ENCLOSURE 1

SHEARON HARRIS NUCLEAR POWER PLANT
DOCKET NO. 50-400/LICENSE NO. NPF-63
RETYPE TECHNICAL SPECIFICATION PAGES
REACTOR COOLANT SYSTEM PRESSURE-TEMPERATURE LIMITS

FIGURE 3.4-2

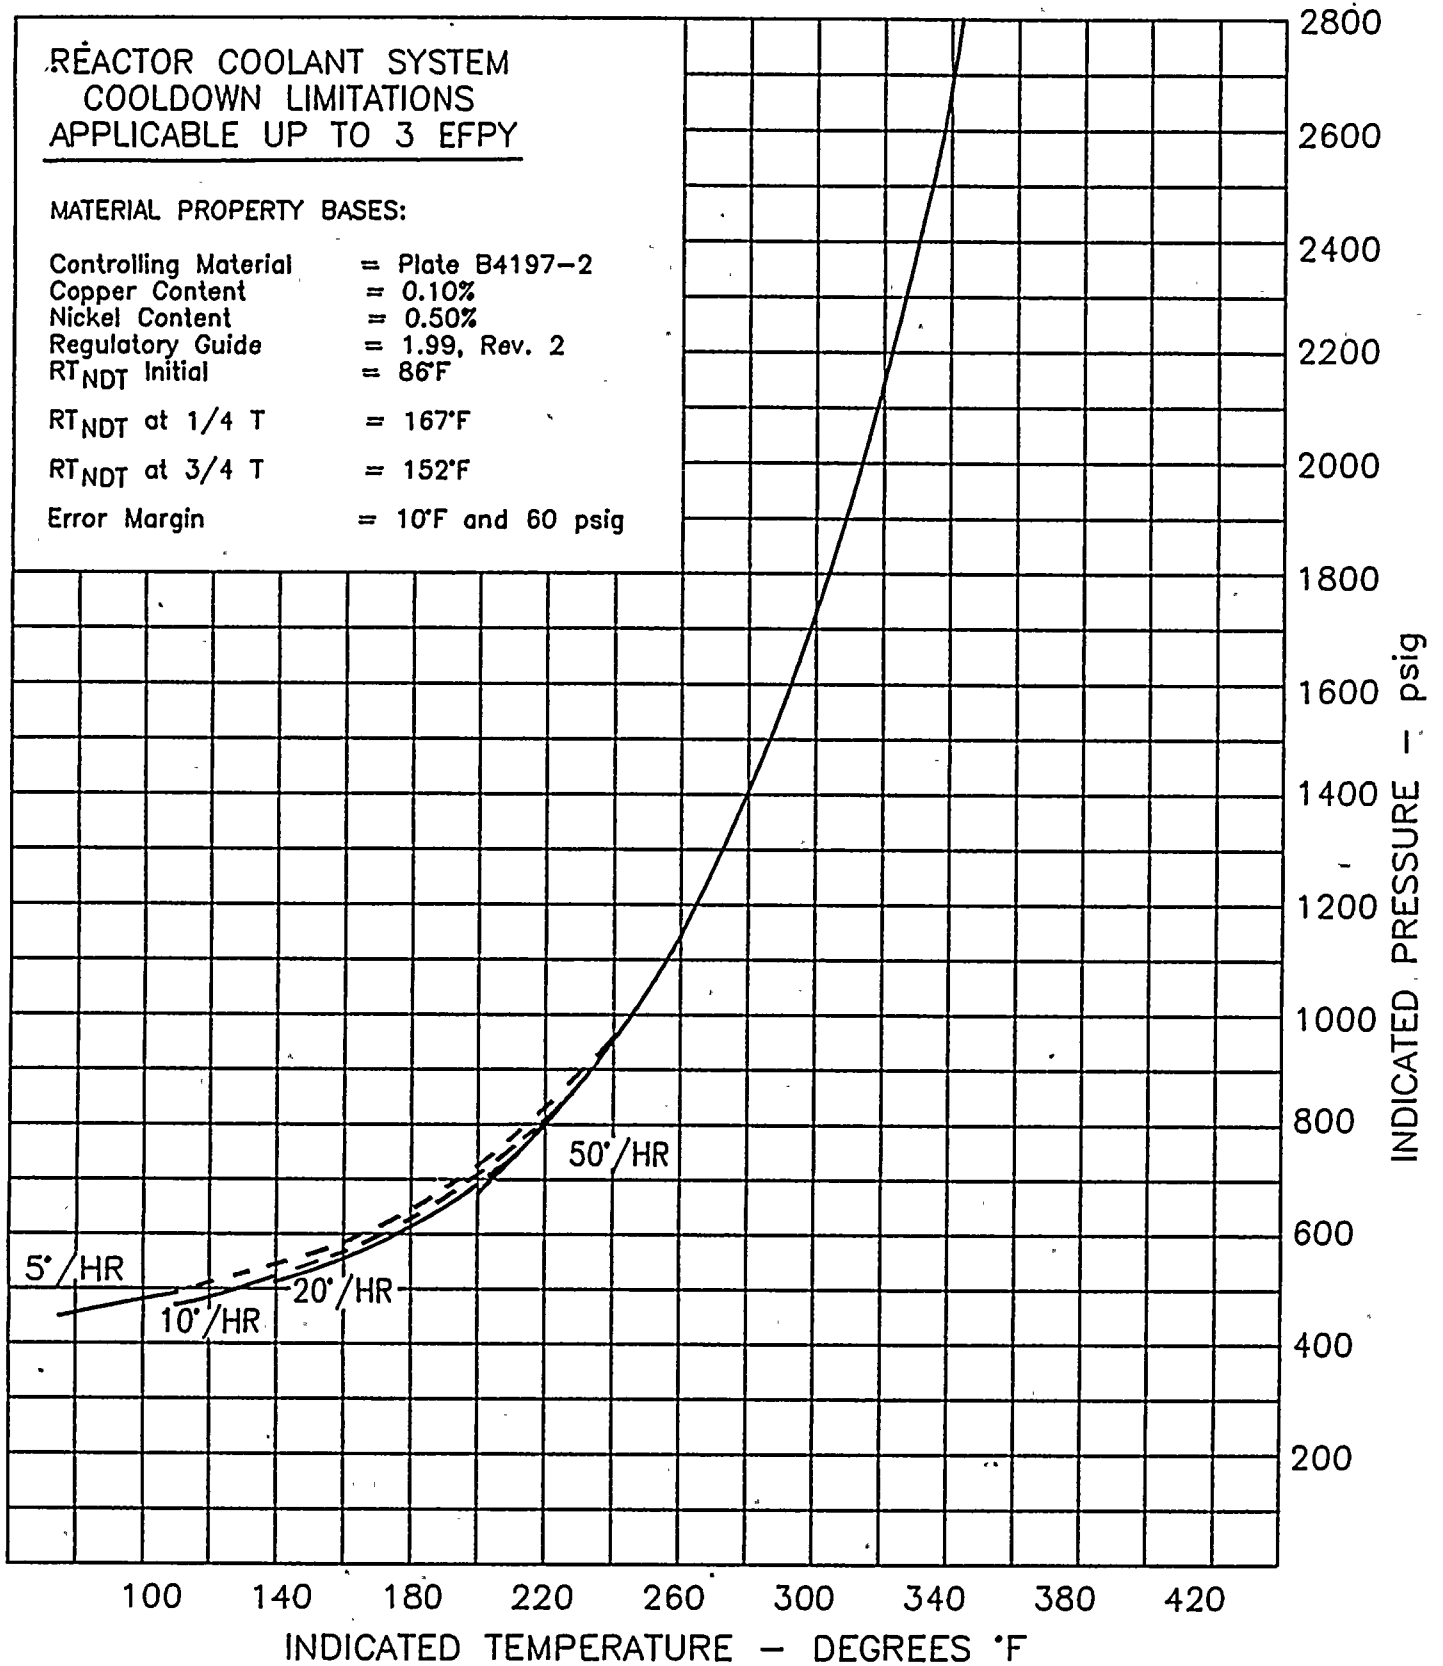
**REACTOR COOLANT SYSTEM
COOLDOWN LIMITATIONS
APPLICABLE UP TO 3 EFY**

Controlling Material = Plate B4197-2
 Copper Content = 0.10%
 Nickel Content = 0.50%
 Regulatory Guide = 1.99, Rev. 2
 RT_{NDT} Initial = 86°F
 RT_{NDT} at 1/4 T = 167°F
 RT_{NDT} at 3/4 T = 152°F
 Error Margin = 10°F and 60 psig

FIGURE 3.4-3

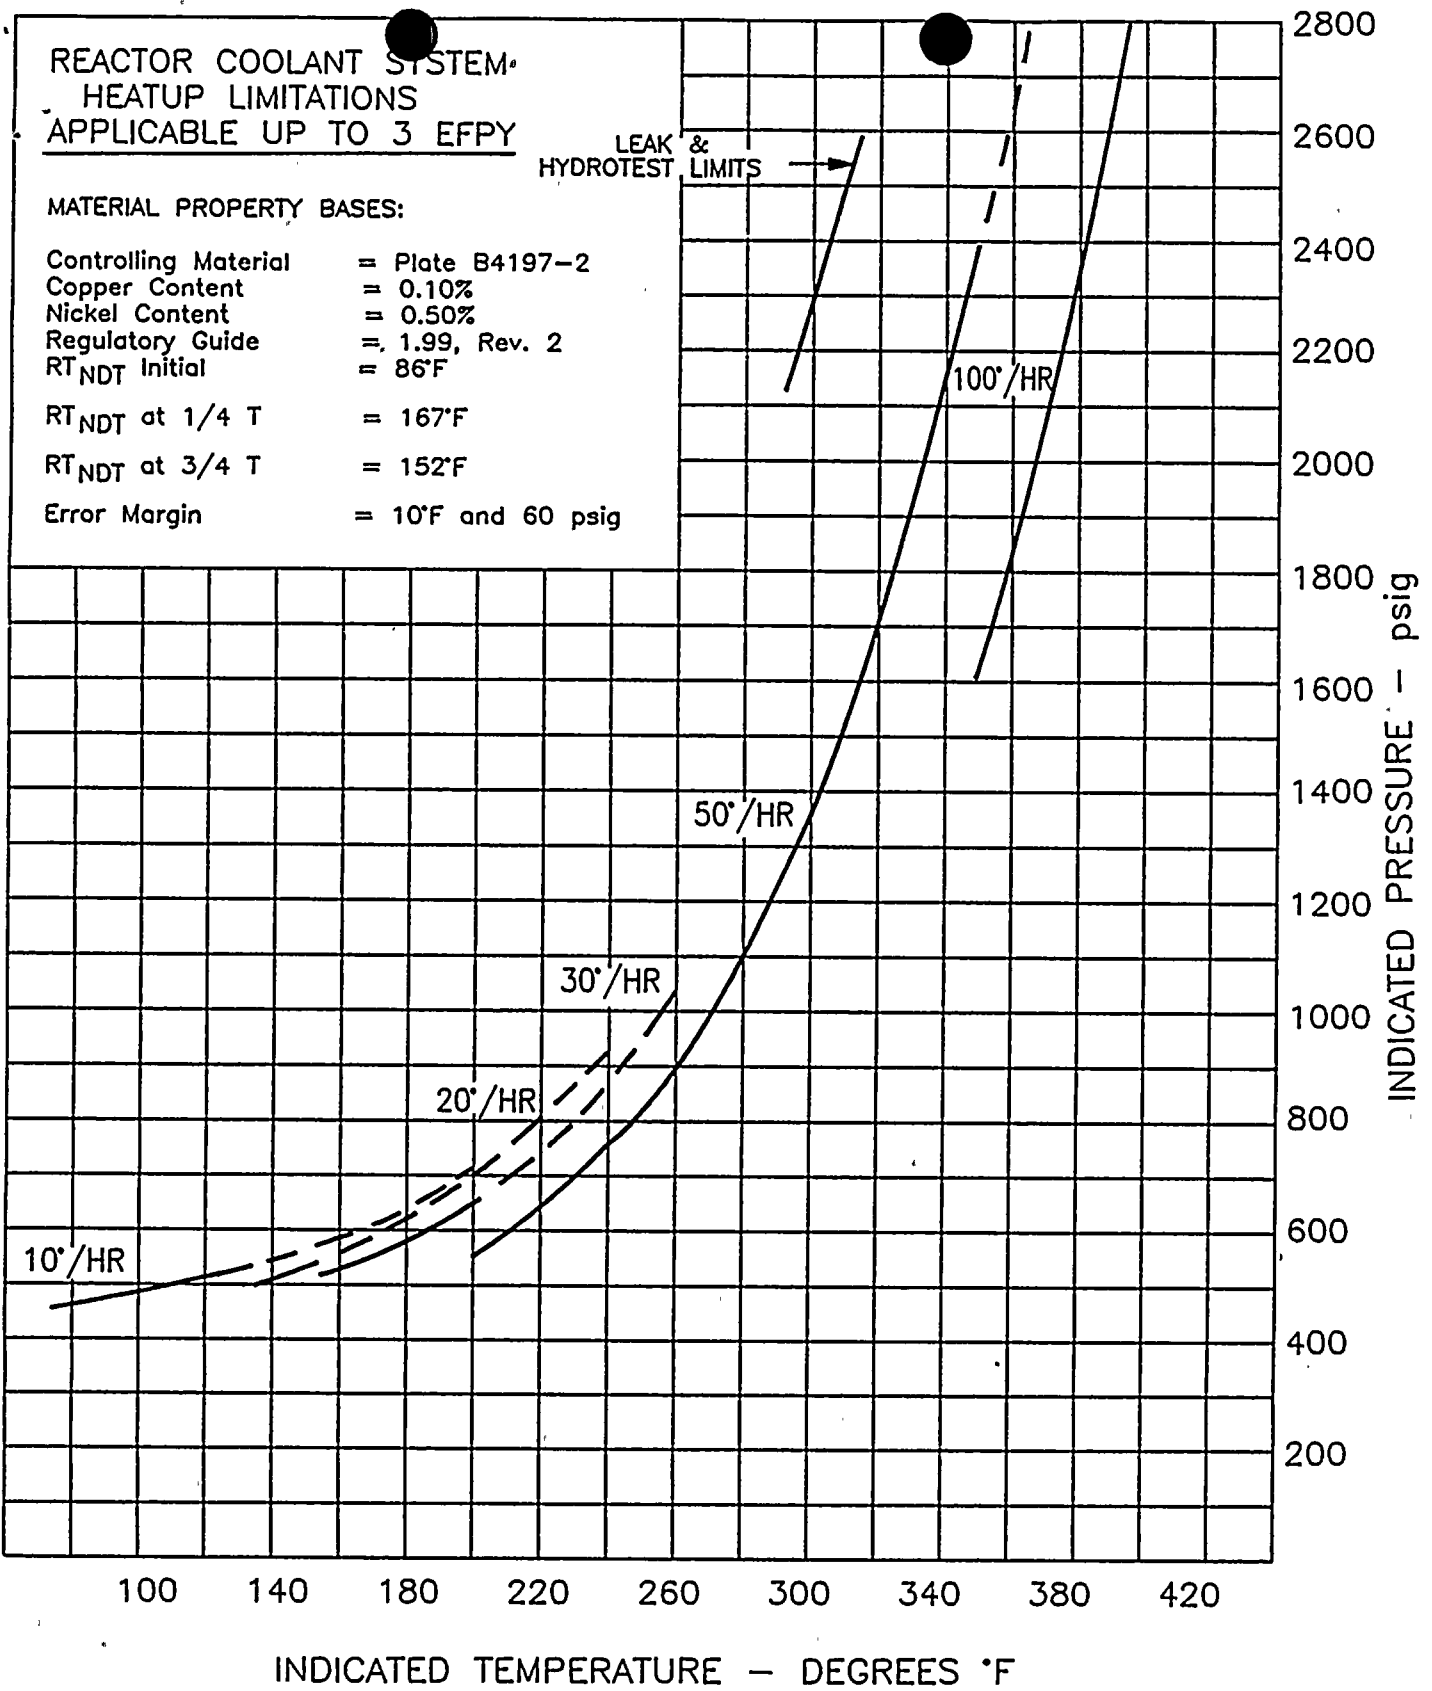
**REACTOR COOLANT SYSTEM
HEATUP LIMITATIONS
APPLICABLE UP TO 3 EFPY**

Controlling Material	=	Plate B4197-2
Copper Content	=	0.10%
Nickel Content	=	0.50%
Regulatory Guide	=	1.99, Rev. 2
RT _{NDT} Initial	=	86°F
RT _{NDT} at 1/4 T	=	167°F
RT _{NDT} at 3/4 T	=	152°F
Error Margin	=	10°F and 60 psig
